6642A-07

# Modification Recommended Service Note

## 6642A DC power supply, 0-20 V, 0-10 A, 200 W. GPIB

Serial Numbers: "MY53000140 to MY53000698 and SG53000101 to SG53000108"

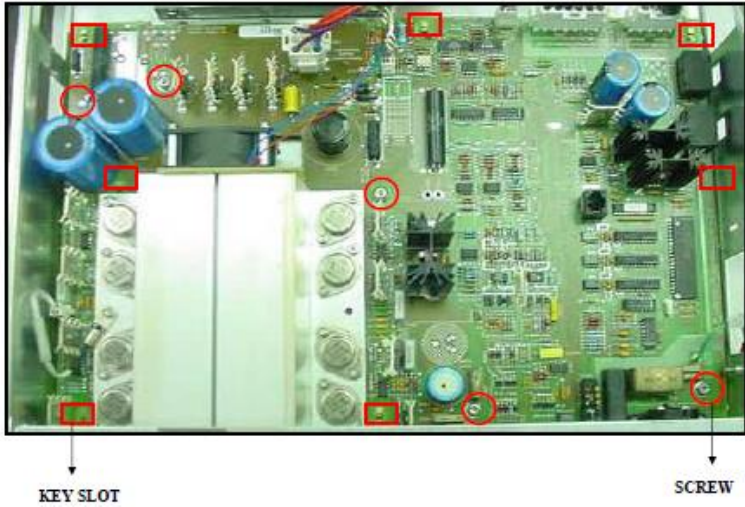
7. Replace with a new PCA board (06642-61030)
